# Cover Letter for KLF Proposal PR12-17-001 Submission to PAC45

## Response TAC Physics Report

## Response on ITAC Report

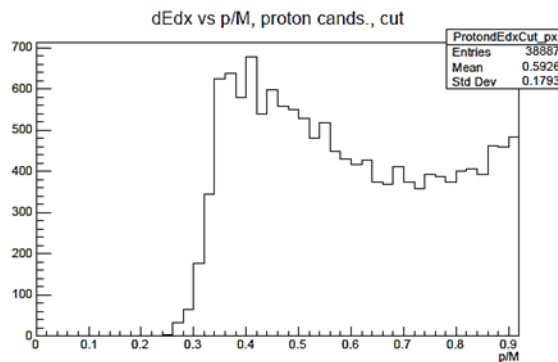
**Q2:** Simulations show that the minimum recoil proton momentum detectable with the proposed target and current GlueX detector is about 0.5 GeV/c as shown in Figure **45**. This includes the full  $K_L$  momentum spectrum as shown in Figure **16**. It is not obvious that at low initial  $K_L$  momenta the proposed measurements can be exclusive and detect the recoiling proton which is essential for

vertex reconstruction. Note that most events in Figure 37 (low  $t$ ) would be undetectable in an exclusive measurement.

**A2:** Figure 45 of the proposal shows particle identification plots for protons in two regions of the GlueX detector. For protons with  $\theta < 10^\circ$  (upper right of Fig. 45), the threshold is in indeed  $p = 0.5$  GeV/c. However, for recoil protons produced at large polar angles the threshold for detection is  $p = 0.3$  GeV/c as shown in the upper left panel of Fig. 45 and figure below of reconstructed proton  $p/M$  for the  $K_L p \rightarrow K_S p$  reaction.

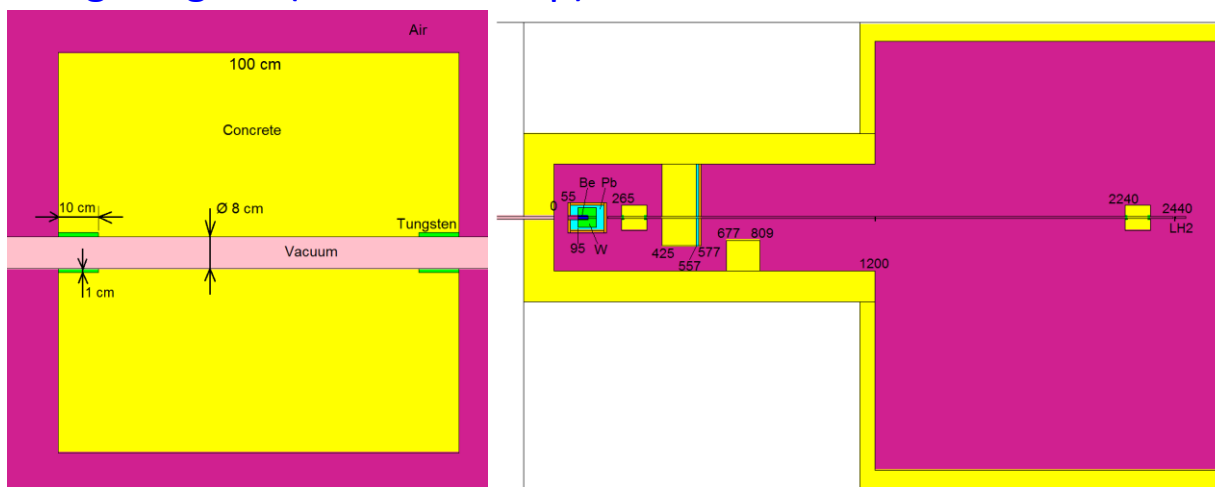
**Q3.** There is no information about the two collimators that are shown as part of the  $K_L$  beam line right after the sweeper magnet and upstream of the GlueX detector (Figs. **14** & **20**). This second collimator is directly competing with the LH target for space on the upstream platform. No information about the collimator material, its dimensions, bore diameter and weight are available. This is important to determine the floor load, in particular on the upstream detector platform.

**A3:** Collimator C1 is a part of the current Hall D photon beam line while collimator C2 is the same. Material for both collimators is concrete with small tungsten components. Sizes are given on left figure below (view from top). The highest above floor is 340 cm. The location of both collimators shown on right figure (view from top).
